CERTIFICATE OF APPROPRIATENESS

Property: 1031 Le Green Street, Lot 13, Block 110, North Norhill Subdivision. The property includes a historic 1,190 square foot one-story wood frame single-family residence and detached garage situated on a 5,000 square foot interior lot.

Proposal: Alteration – Alter the fenestration of the existing south (front) and east elevations of the historic residence.

HAHC Action: Denied

SOUTH ELEVATION – FRONT FACING LE GREEN STREET

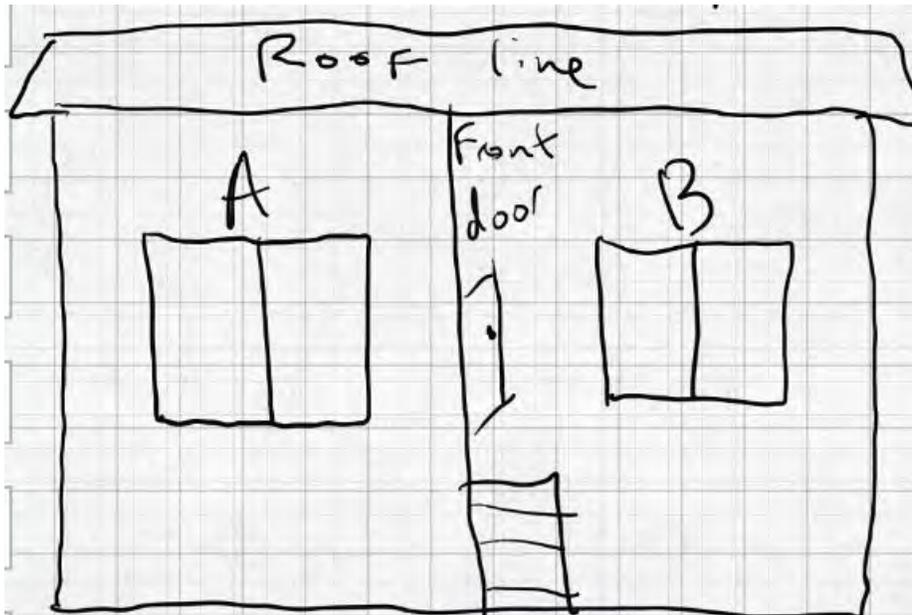
<i>The removal of the original windows, trim, and siding as well as the addition of paired windows to the façade of this building is highly visible and represents a failure to retain and preserve the historical character of the property.</i> |

<i>A single window located in each of the two front bays was a highly visible and distinguishing characteristic of this residence. No evidence has been submitted supporting that this residence originally had paired windows on the front elevation. Adding additional fenestration to the façade of this building is highly visible and alters its original historic appearance.</i> |

<i>No evidence has been submitted supporting that this residence originally had paired windows on the front elevation. Adding additional fenestration to the façade of this building is a highly visible and invasive alteration to its original historic appearance.</i> |

<i>The removal of existing historic windows, the expansion and alteration of the original window openings and the addition of paired windows on the façade and a smaller window on the east elevation impairs the integrity of the historic structure. Additionally, the shifting of windows is extremely invasive. As this is a balloon framed house, the walls will have to be reframed and headers installed to allow for proper installation of the new windows.</i> |

EAST SIDE ELEVATION

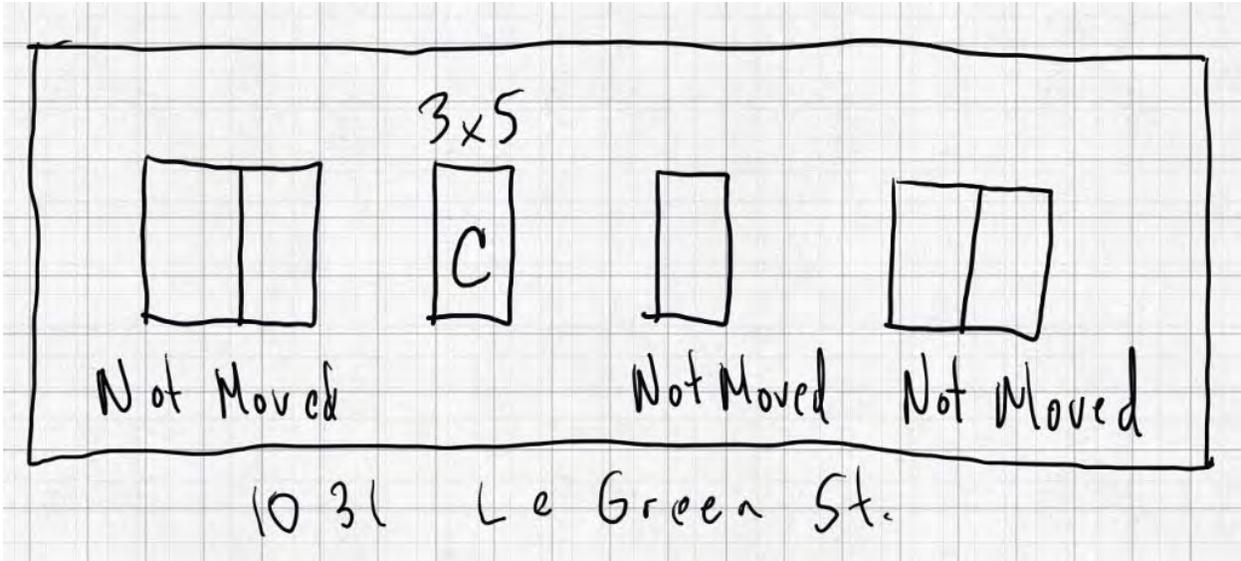
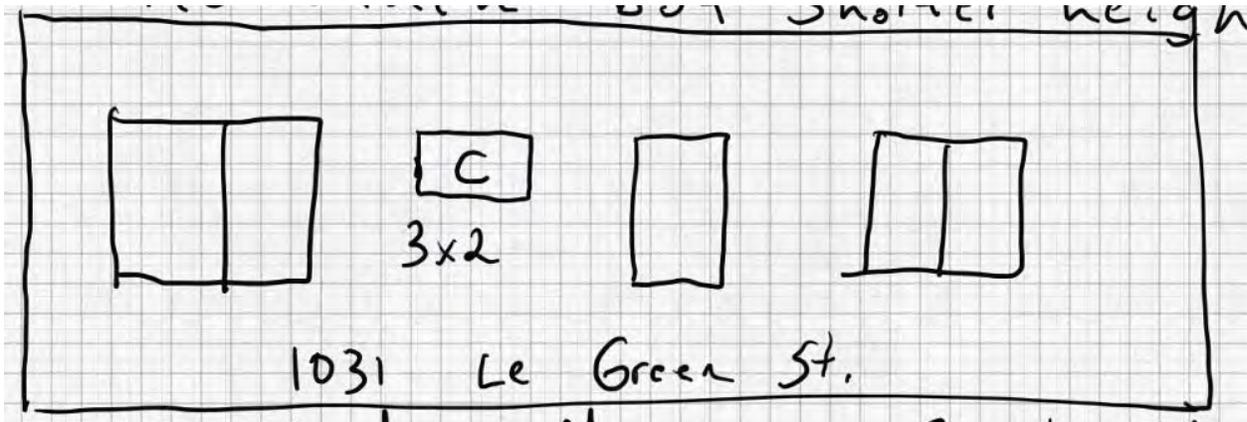
The applicant has removed the smaller window and installed a horizontal slider window in its place. The remainder of the original opening was patched with new 117 wood siding to match existing. See drawings and photos for more detail.
